**Department of Permitting Services
Fire Department Access and Water Supply Comments**

DATE: 11-Dec-23
TO: Patrick La Vay - plavay@mhgpa.com
Macris, Hendricks & Glascock
FROM: Marie LaBaw
RE: Springvale Terrace
120240030

Springvale Terrace
MNCPPC #'s 120240030 & 820240040
MHG Project No. 2020.315.21

RE: Sketch Plan and Preliminary Plan Letter
Sketch Plan No. 320240020
Preliminary Plan No. 120240030
Springvale Terrace
Revised Letter

**FIRE DEPARTMENT
ACCESS PLAN**

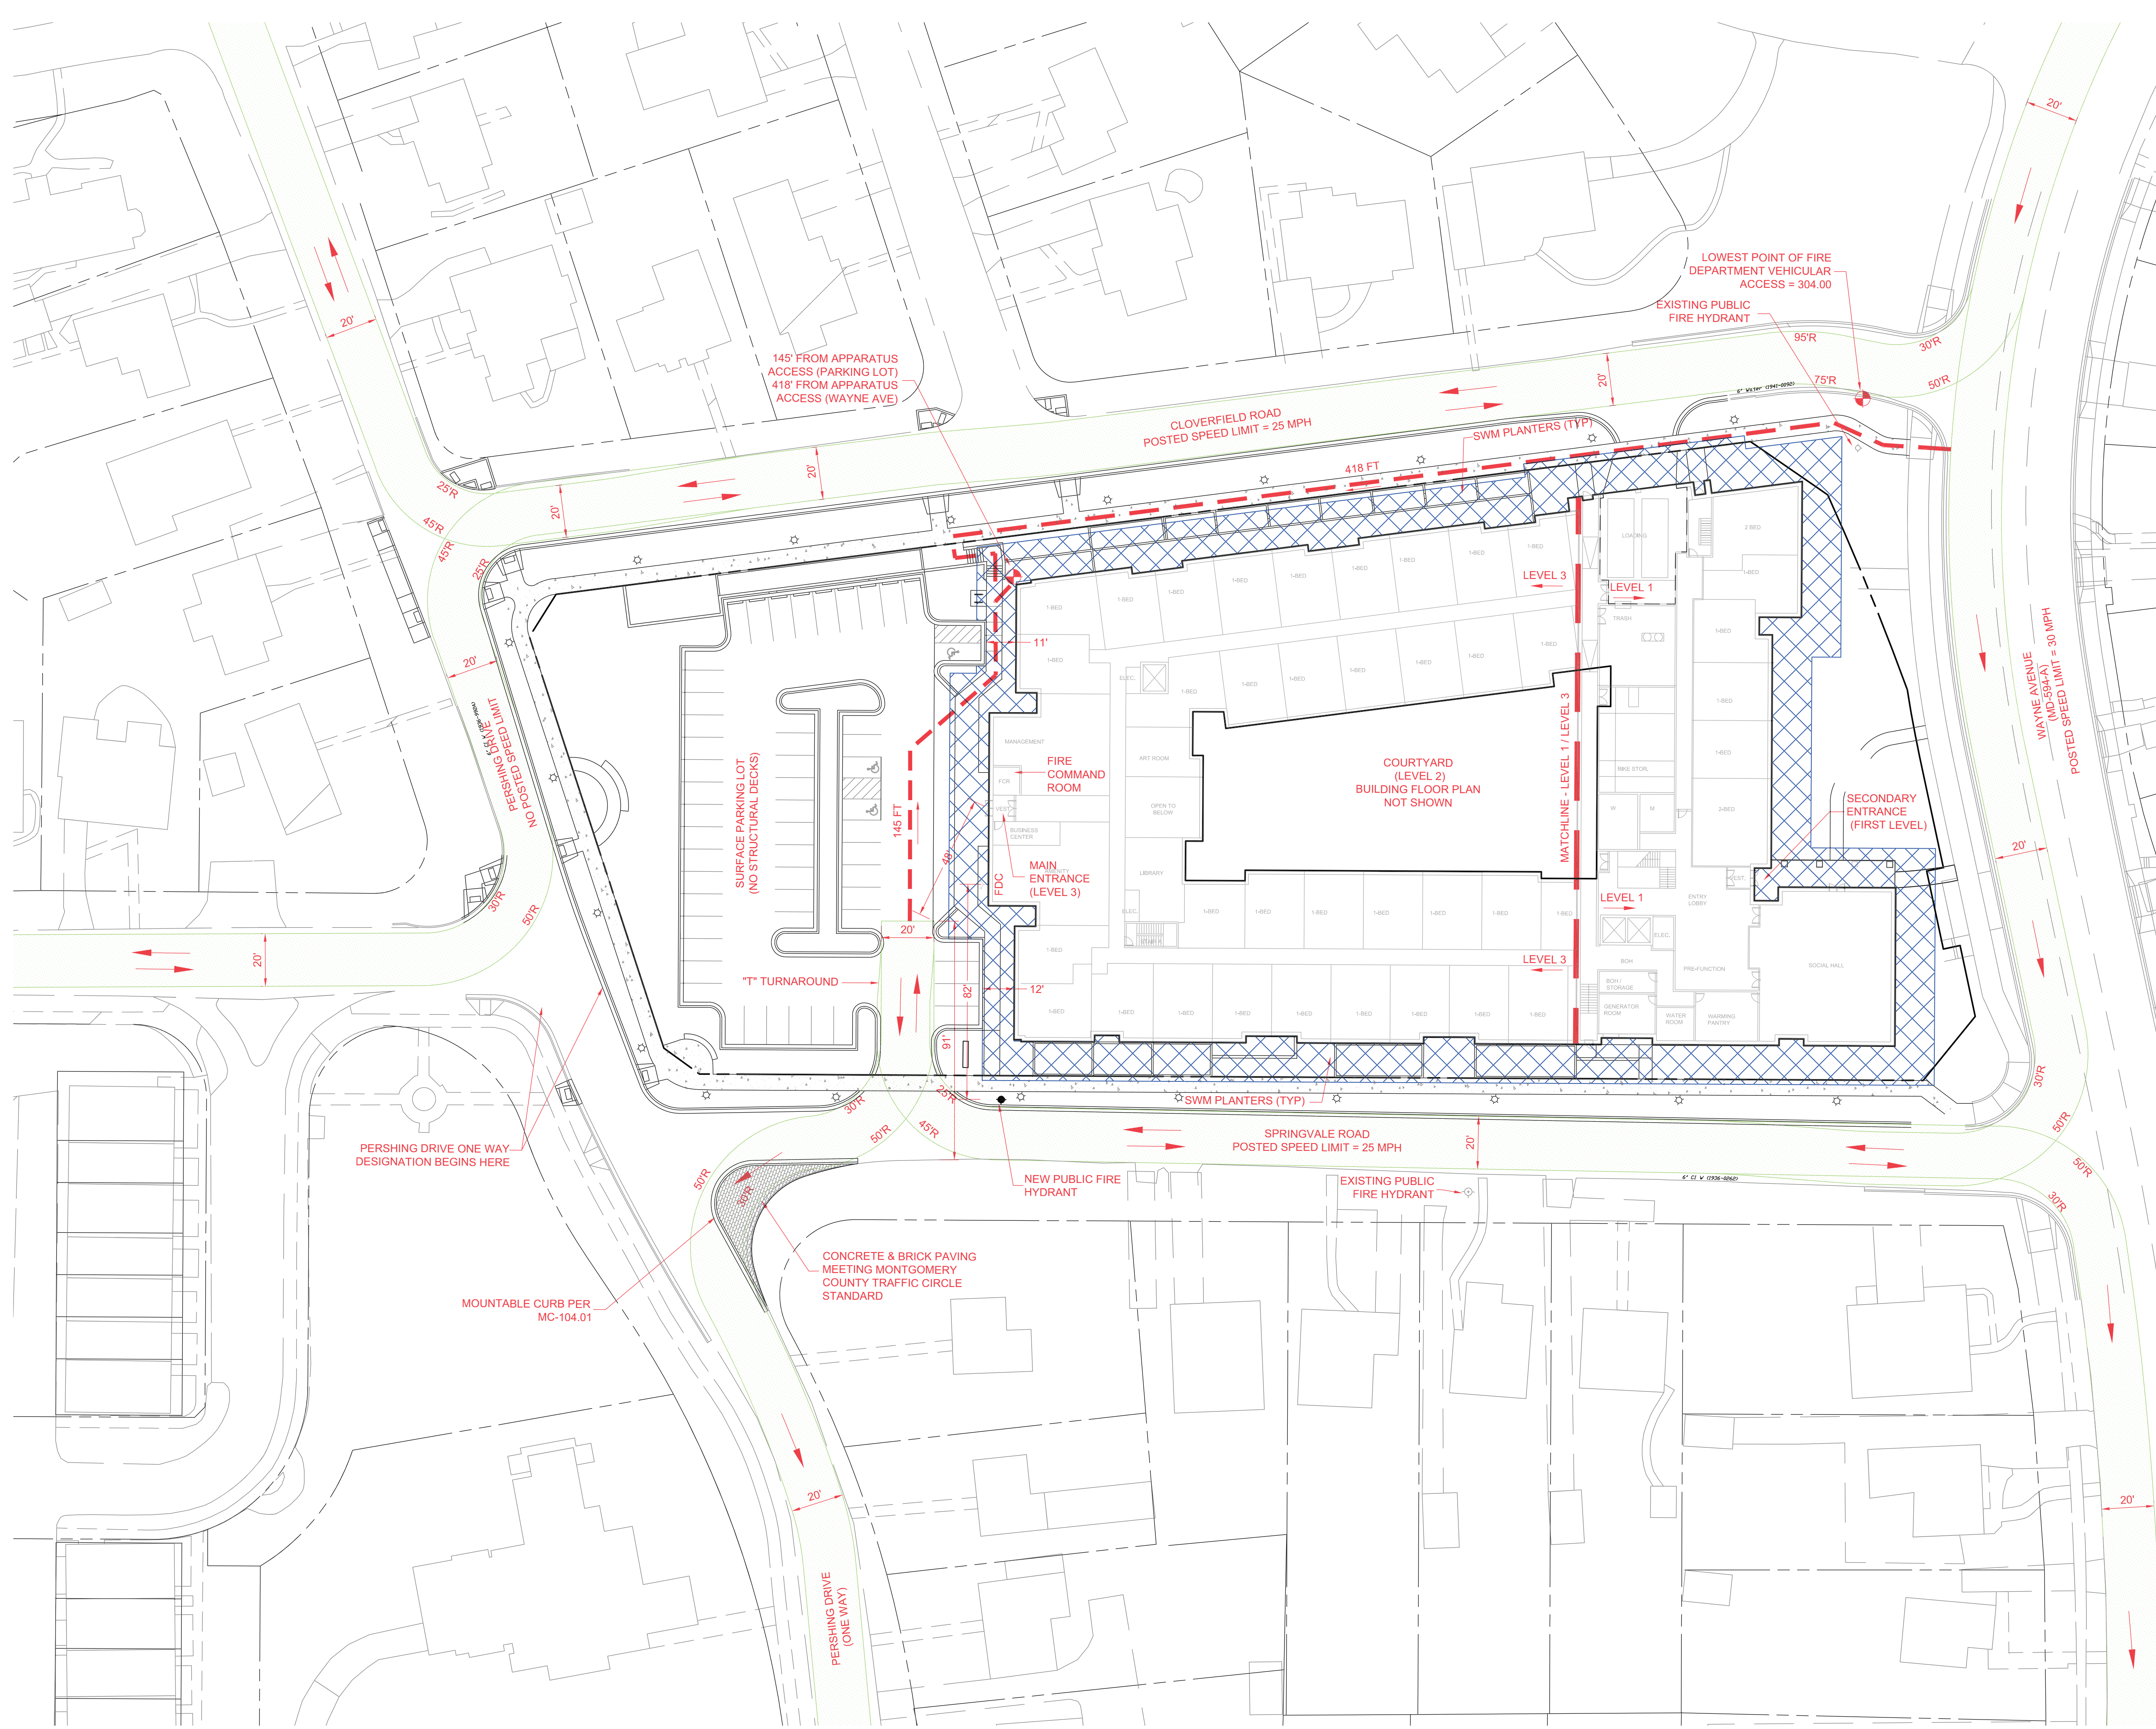
***** 2/5/2024 Revised intersection of Springvale Road and Pershing Drive *****

***** 2/8/2024 Revised intersection of Springvale Road and Pershing Drive *****

On behalf of our client, Enterprise Community Development, we hereby submit a revision to the previously approved Fire Department Access Plan for Springvale Terrace, a new 237-unit affordable senior housing development. The property is located at 8505 Springvale Road in Silver Spring, MD and received approval from the Department of Permitting Services Fire Department Access and Water Supply on February 5, 2024. At the request of MNCPPC and MCDOT Transportation Planning staff, the pedestrian crossing at the southwest corner of Springvale Road and Pershing Drive has been eliminated. This change alters the paving treatment along the previously approved fire department access path, therefore, this revision is being submitted to show the new mountable curb and paving treatment, per Montgomery County Traffic Circle Standards. All other elements related to fire access and water supply remain unchanged.
